Docket Item # 7
BAR CASE # 2009-0005

BAR Meeting
February 18, 2009

ISSUE: Demolition/Encapsulation
APPLICANT: William Cromley, Owner
LOCATION: 426 North Columbus Street
ZONE: CL / Commercial Low Zone

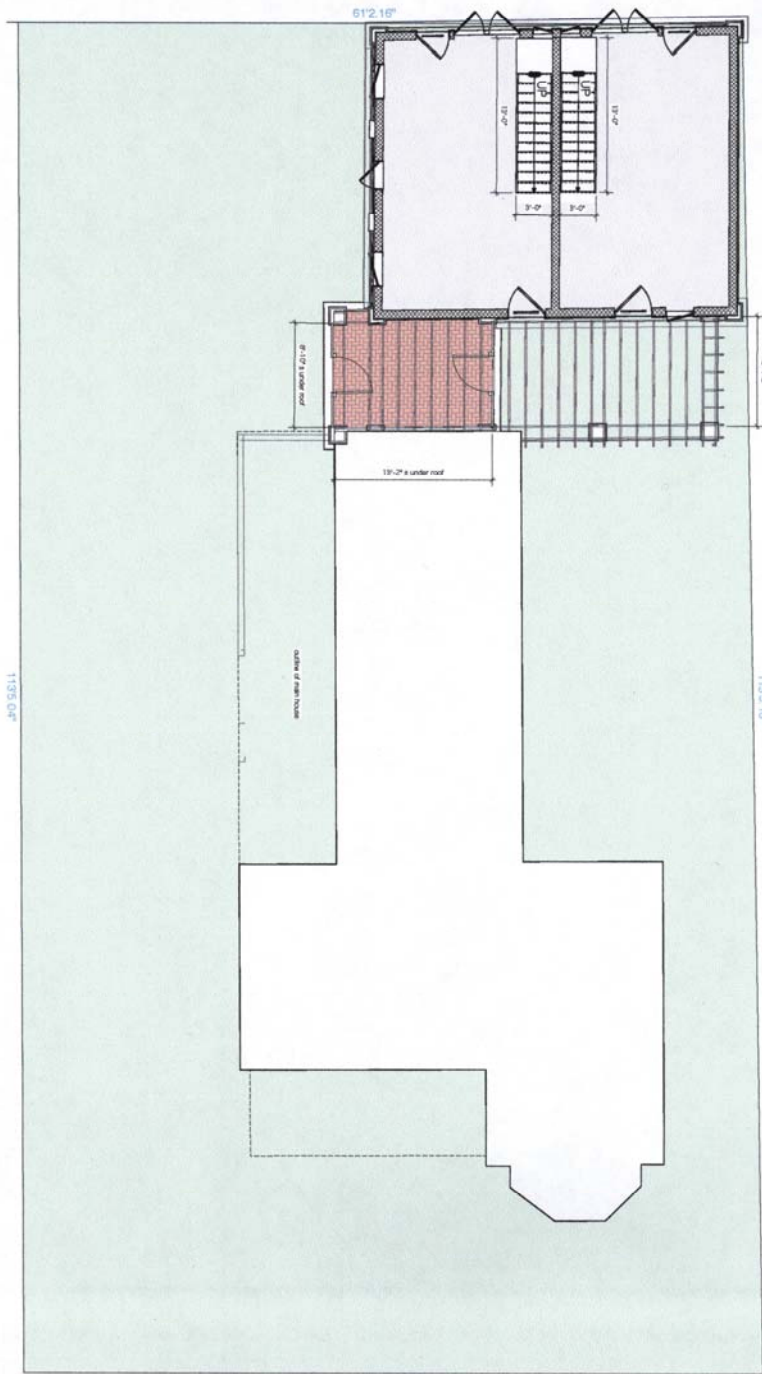
1. Encapsulate 130 sq. ft. of the west elevation of the main massing. This encapsulation is proposed as part of a request to enclose 18' of the existing, one-story shed roof open porch along the south elevation of the ell. The enclosure will be fabricated of painted, wood insulated glass panels with simulated divided-lights.
2. Demolish 32.5 sq. ft. of first floor wall surface on the north elevation of the main house. The goal of this demolition is to determine if there is visible evidence of windows in this location, as it is the Applicant's desire to install two, new, 4/4 true-divided light wood windows in this location. Based on the architectural style of the house and this elevation's current configuration, it is believed that historically the first floor of this house had 4/4 wood double hung windows which matched the existing windows on the elevation's second story.

Figure 16: Mounting Detail of Shed Roof Porch Enclosure to Existing Wood Porch Posts

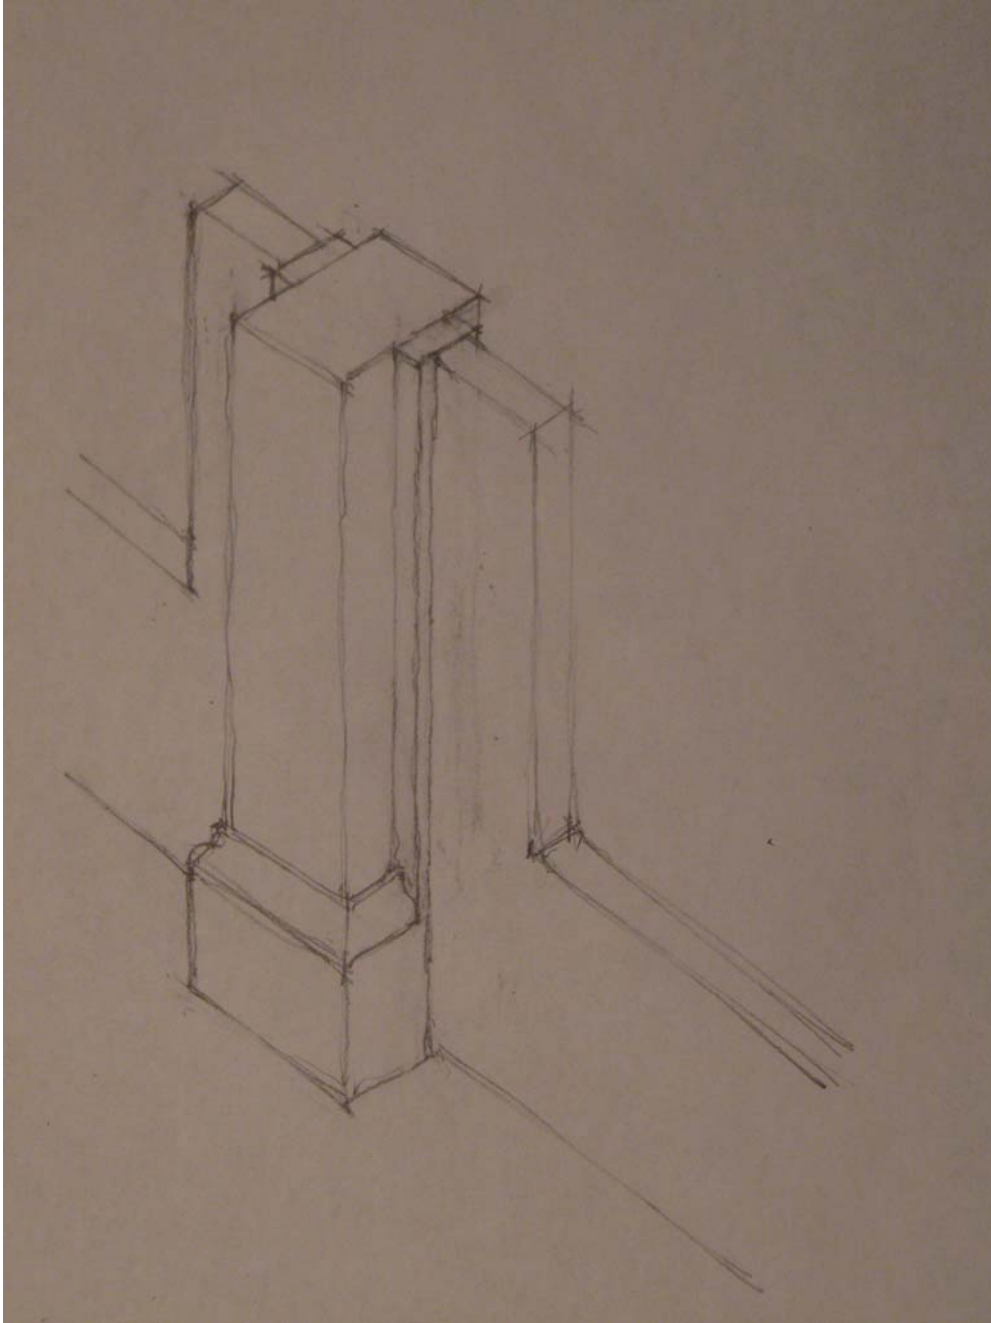
The 130 sq. ft. encapsulation of the rear wall on the main massing will create an 18' long, glass porch enclosure within the existing shed roof porch which currently protrudes from the side/south elevation of the ell extension. The proposed glass panels being utilized to enclose this segment of the side porch will be mounted between the porch's existing square columns. BAR staff has developed a design detail with the Applicant to ensure that the original porch columns will not be damaged during the installation of these panels and to provide an opportunity for a future owner to return the porch to its open configuration without any damage to the historic architectural details (see Figure 16).
